SERVICE BULLETIN Amateur Radio Division

SUBJECT	DATE
TS-950S Final Amplifier Bias Circuit Change	January 23, 1992

Final Unit (X45-3330-00) Component Side View

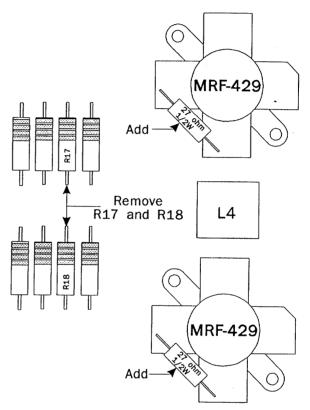
It is possible to exceed the maximum Vcbo rating of the MRF429 transistors used in the TS-950S/SD if the unit is operated at excessive transmit power levels (greater than the normal factory output power setting.) This results in a collector to base short on the MRF-429. This causes excessive current to be drawn thru R17 and or R18 of the final bias circuit. This can cause a large amount of smoke from the overloaded resistors. It does not normally cause damage to surrounding components. (You might wish to chect Q7, VR2, Q8 and the fuse just as a precaution!)

R17 and R18 are carbon type resistors (27 ohms 1/2 w). Carbon resistors can emit quite a bit of smoke when overloaded in this manner and can be the cause of considerable concern by the operator!

In order to ease operator concern we recommend replacing R17, and R18 on the final unit (X45-3330-00) with ceramic resistors whenever replacing the final transistors. These special resistors have been designed to open quickly if the current rating is exceeded. This prevents smoking and the odors associated with burning resistors!

4. R17 and R18 must be replaced whenever you replace the final transistors. The ceramic resistors are easy to identify. They are rectangular and white in color.

- 1. Replace the bad MRF-429 transistors.
- Remove R17 and R18 from the compo-2. nent side of the Final circuit board.
- 3. Solder the ceramic resistors directly to the base and emitter of the final transistors. The stability of the circuit is improved by soldering R17 and R18 directly to the base and emitter of the finals. Do not install them in the old locations!
